RE: 17TH STREET CANAL PARALLEL FLOOD PROTECTION
PHASE 1B - HAMMOND HIGHWAY TO SOUTHERN RAILWAY
OLB PROJECT NO. 2043-0207

In your letter of October 21, 1988, you listed comments on our preliminary plans for the above referenced project. In our review of those comments, we discovered that the slope stability calculations for the first six reaches of this project do not properly reflect the actual factors of safety.

We are submitting revised slope stability and sheet pile analyses for Reaches 1 through 6 which supersede the previously submitted calculations and consequently make obsolete comments "a" and "b" of your letter of October 21, 1988.

REACH 7 OK SAME AS GDM
STA. 643+00 TO STA. 663+00

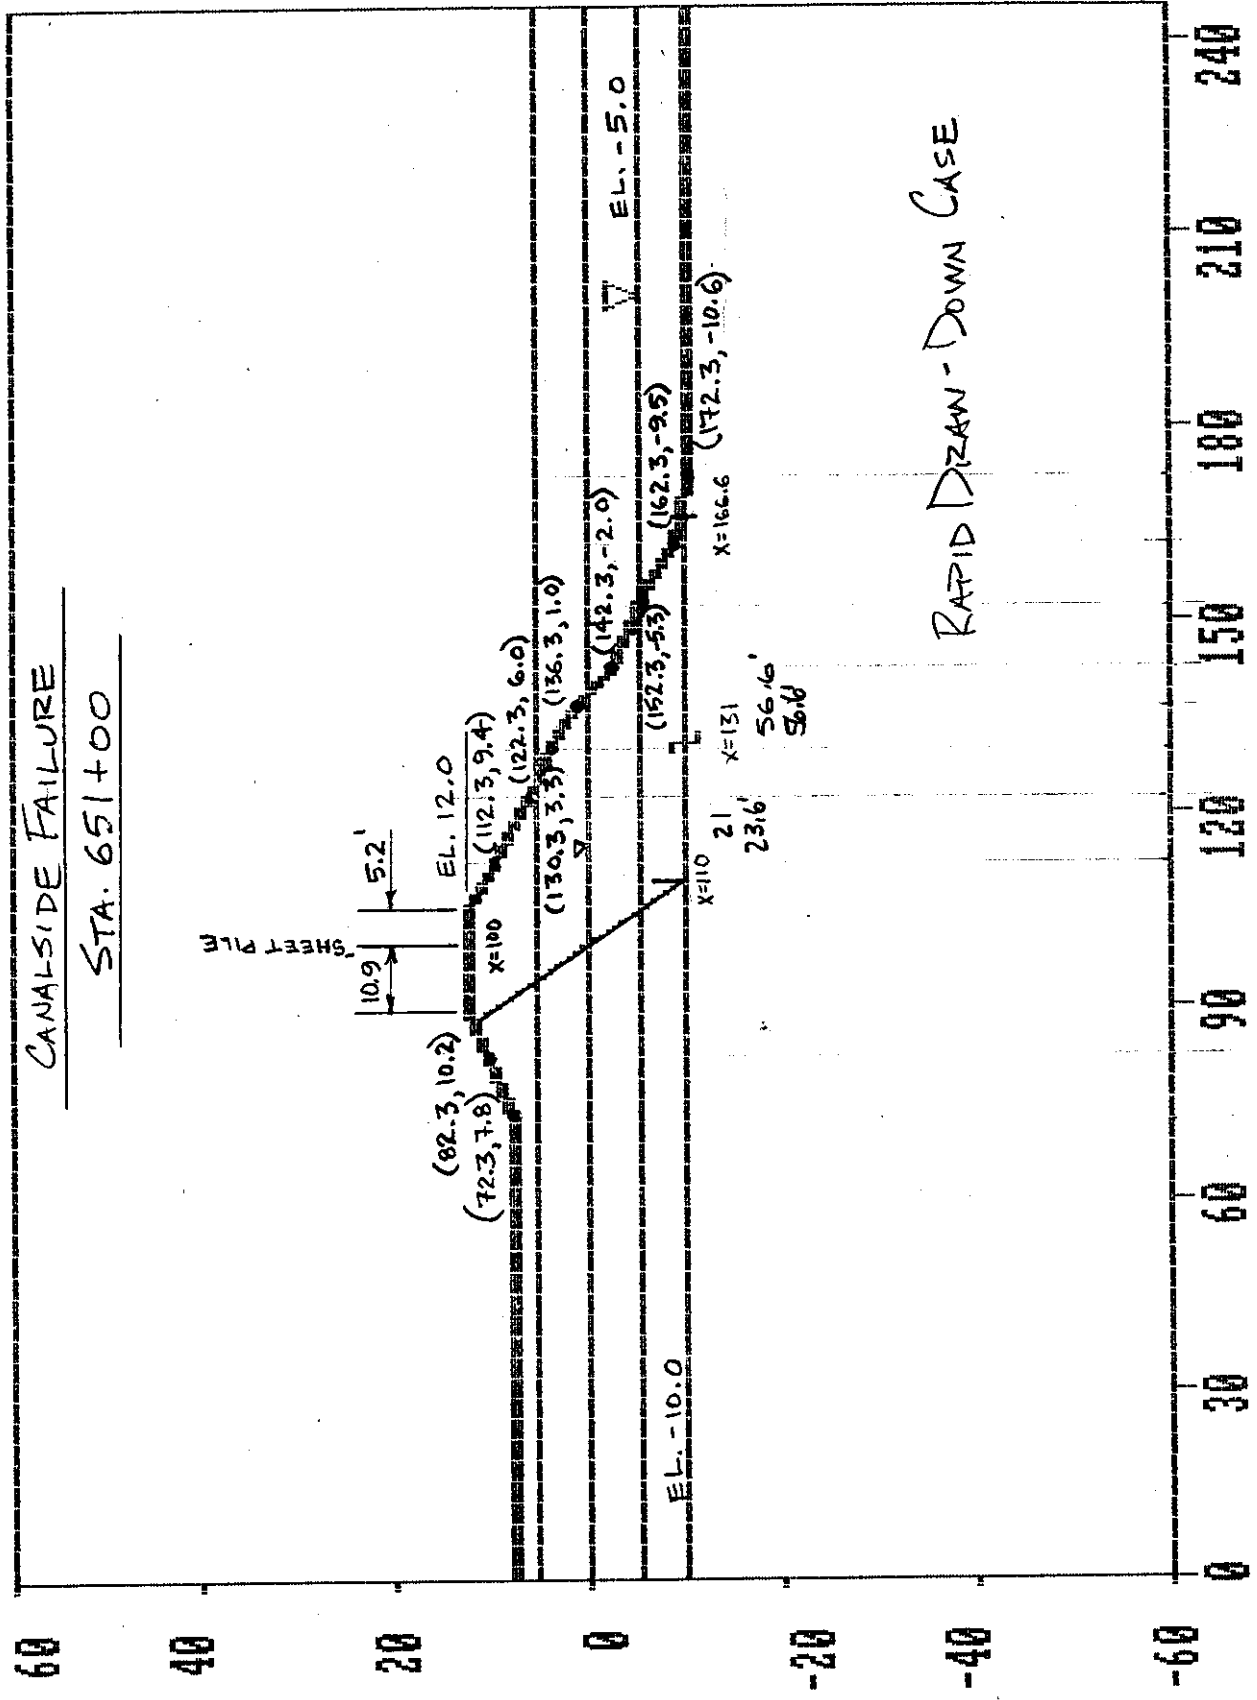
Revisions to Cross-Section : Lower Crown Elevation to El. 12.0
Total Crown Width Increases Accordingly

CANALSIDE FAILURE
STA. 651+00

$$F.S. = \frac{R_A + R_B + R_P}{D_A - D_P} = \frac{18,084 + 15,152 + 19,202 + 15,386 + 0}{25,808 - 0} = \frac{67,824}{25,808} = 1.31$$

REACH 8
STA. 663+00 TO STA. 670+00

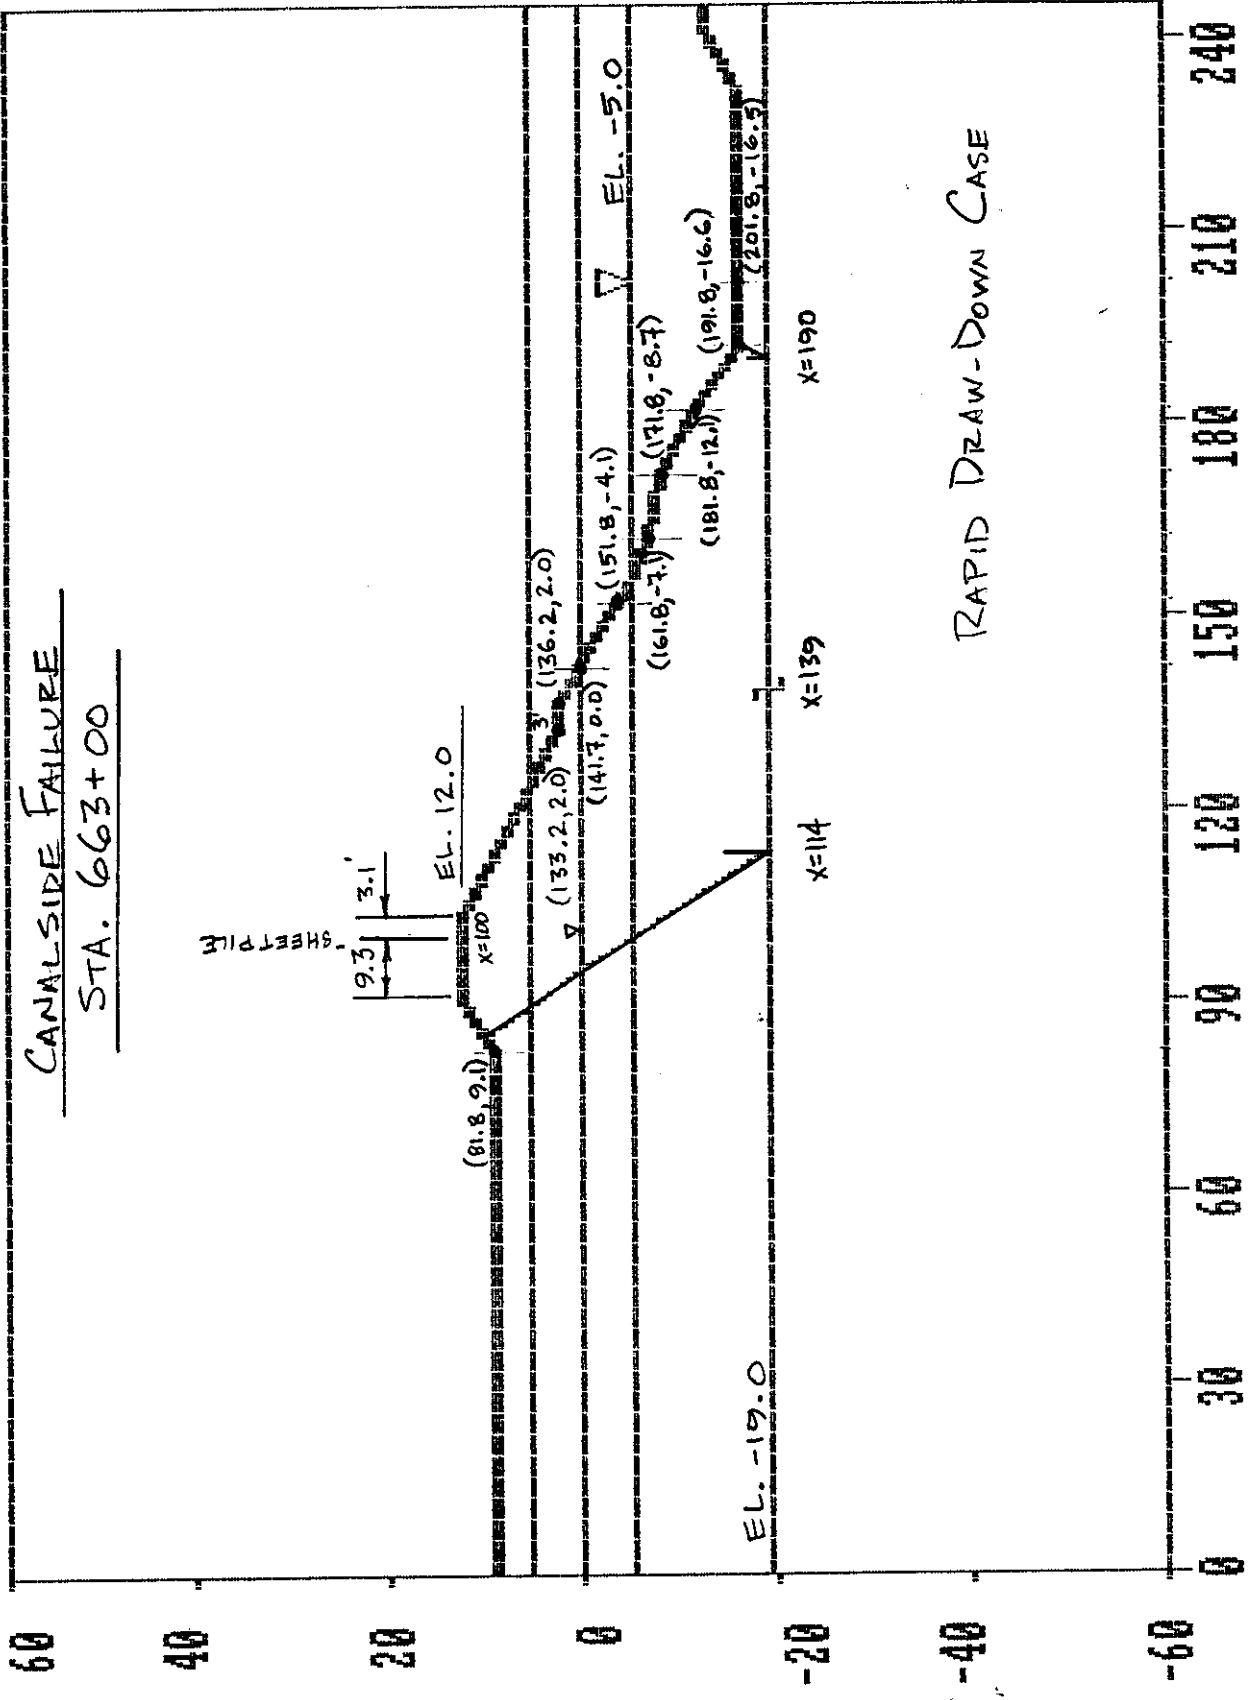
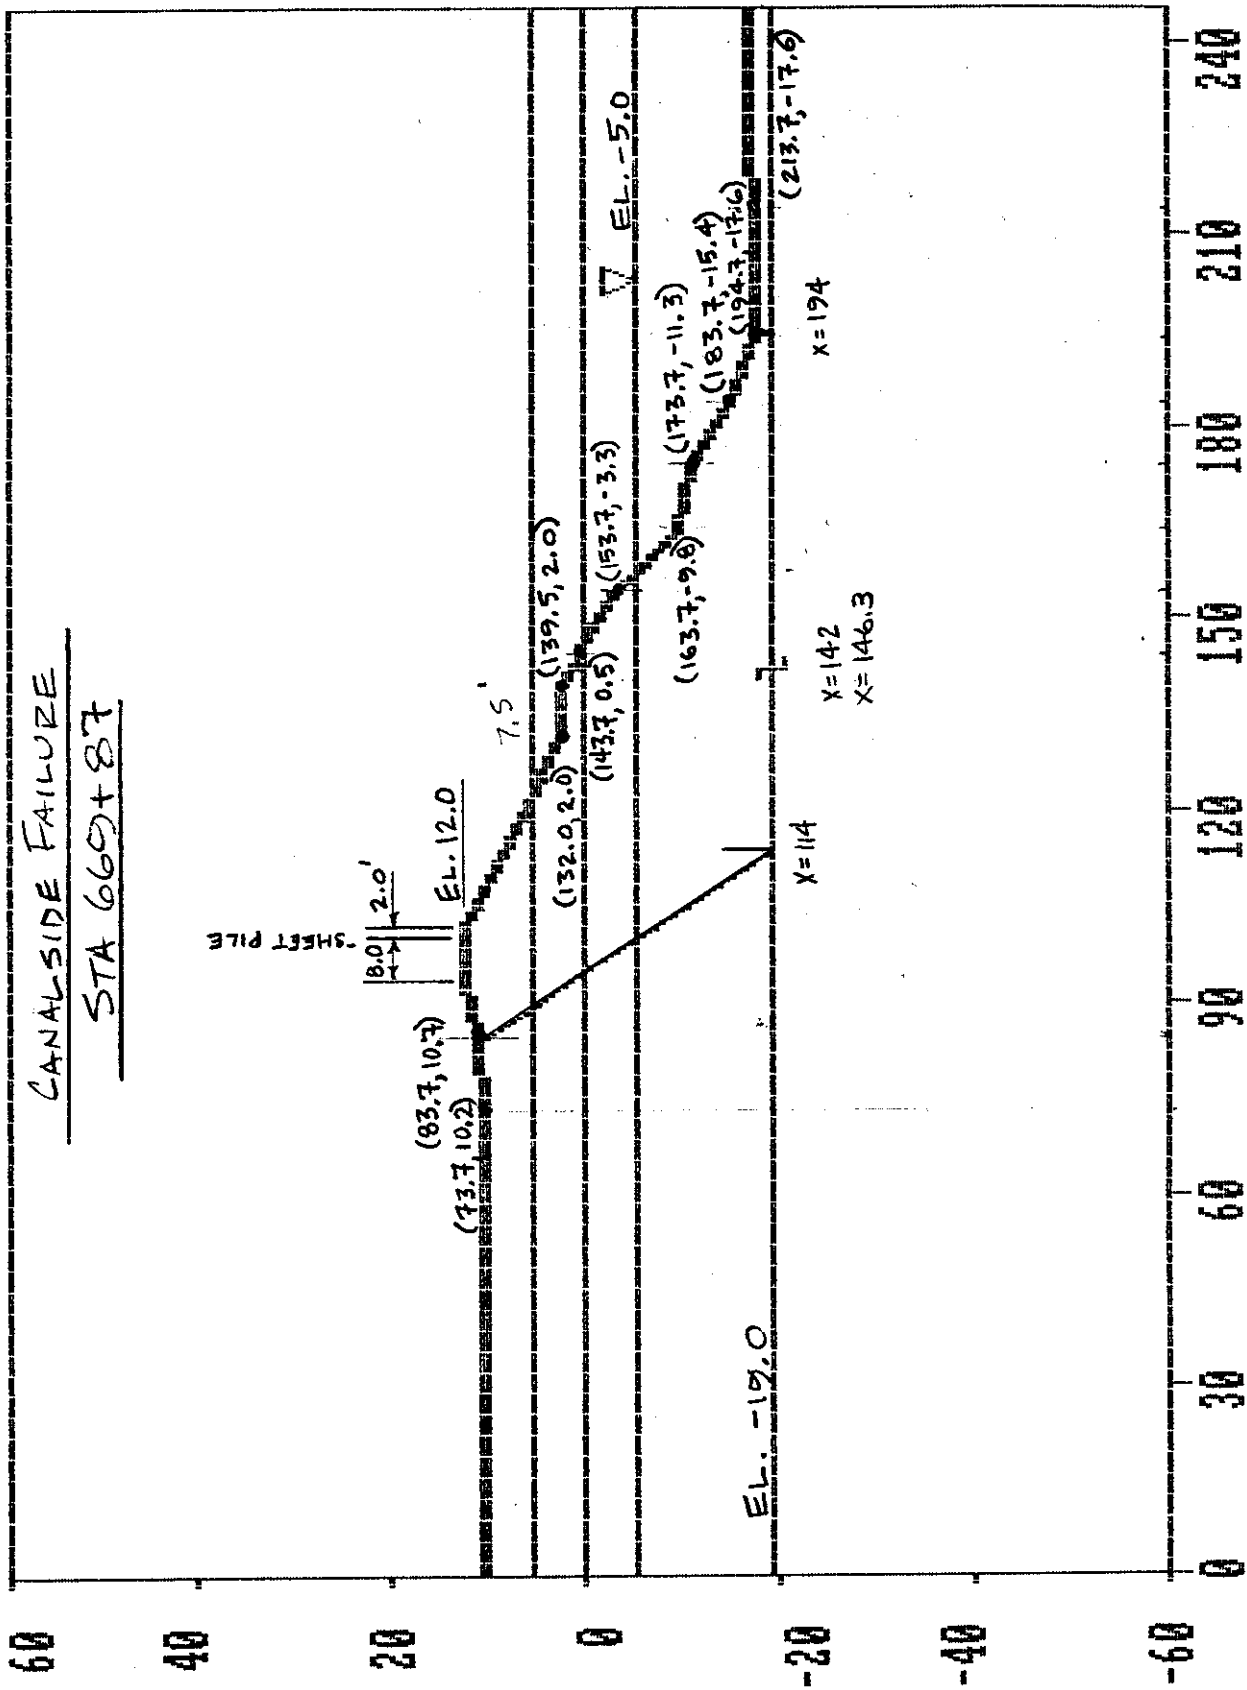
Revisions to Cross-Section : Lower Crown Elevation to El. 12.0
Hold 8.0' Crown Width Behind Sheet Pile Wall
Hold 2.0' Crown Width in Front of Sheet Pile Wall
Step Width Increases Accordingly

CANALSIDE FAILURE
STA. 663+00

$$F.S. = \frac{D_A + D_B + D_P}{D_A - D_P} = \frac{26,282 + 29,018 + 2,263}{44,048 - 158} = 1.31$$

CANALSIDE FAILURE
STA 669+87

$$F.S. = \frac{R_A + R_B + R_P}{D_A - D_P} = \frac{26,980 + 28,224 + 1,306}{43,499 - 44} = \frac{56,510}{43,455} = 1.30$$
